**RFP-MCC-2313**  
**Design / Build of Two Fire Stations**  
**Addendum #3**

**To All Bidders of RFP-MCC-2313:**

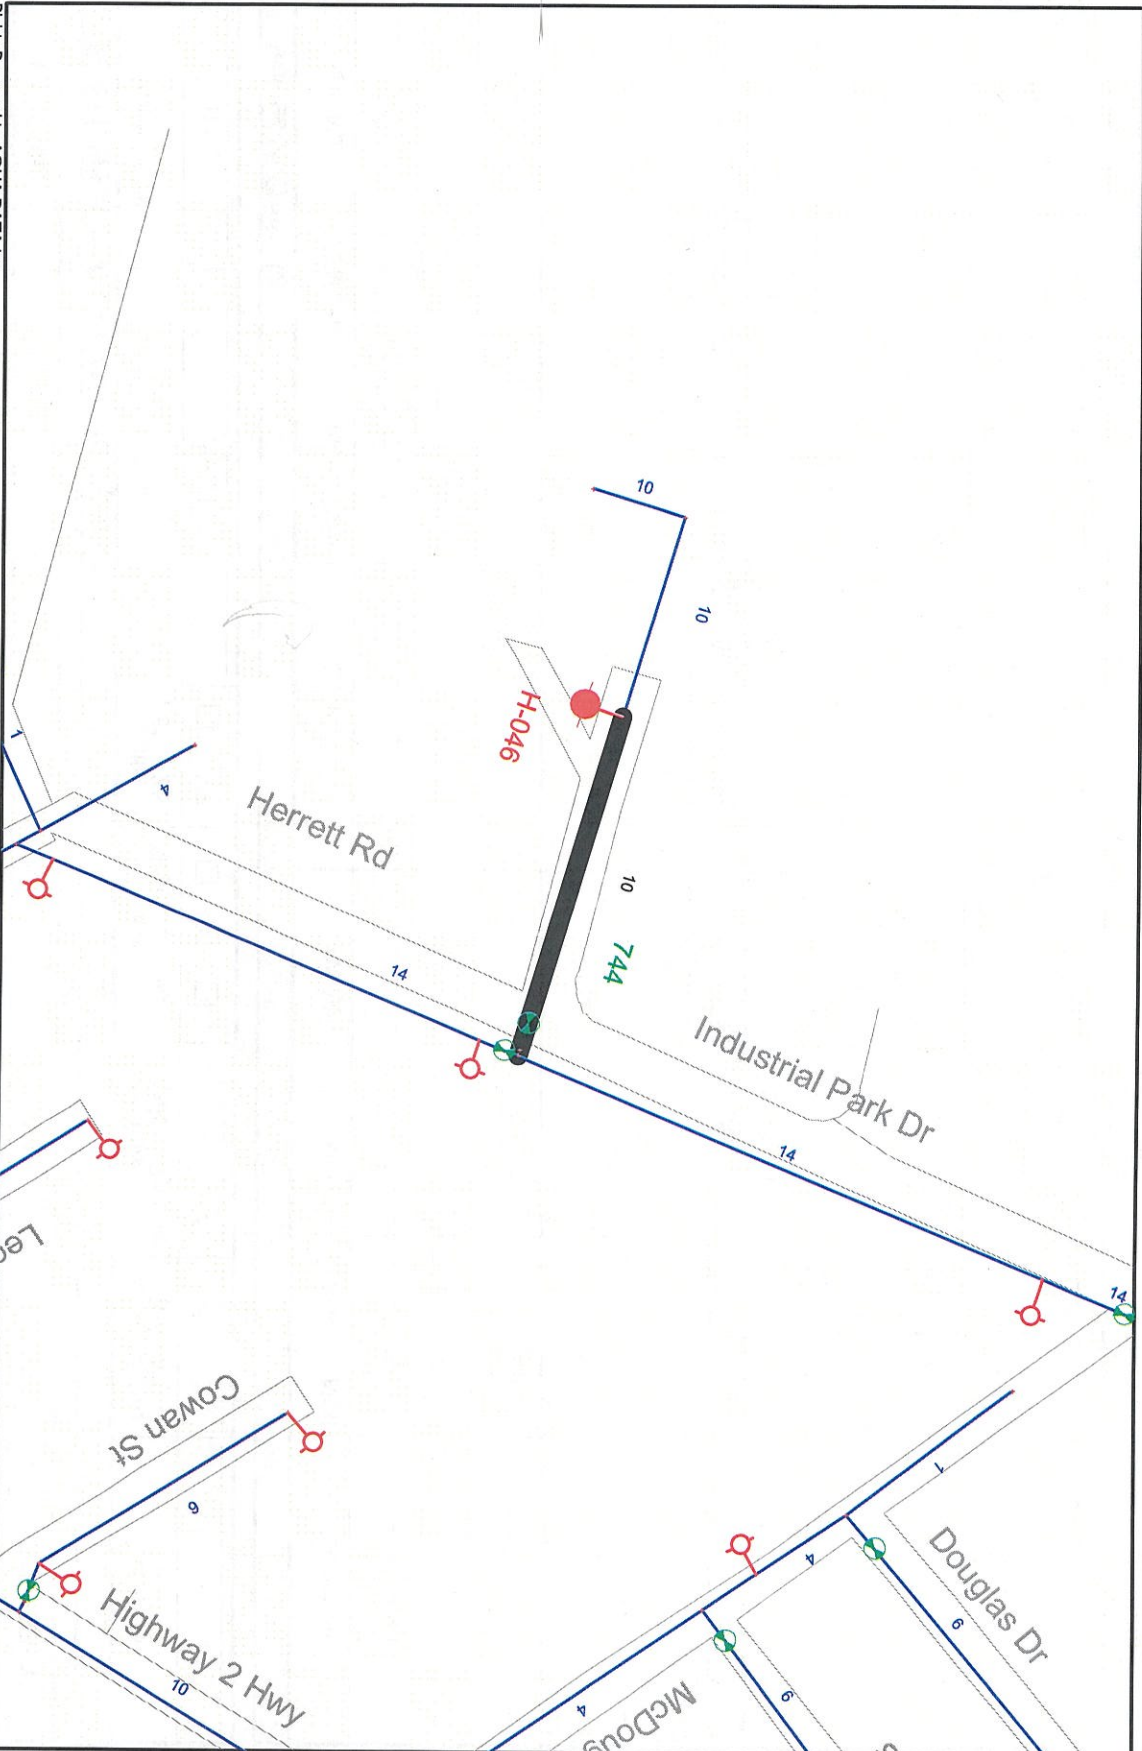
6. Can the county conduct a flow test in each of the site areas to determine existing static water pressure as it may impact the size of the water lateral.

Springhill test results are attached. Tests for Parrsboro will be completed in the coming week and will be posted at that time as a separate addendum
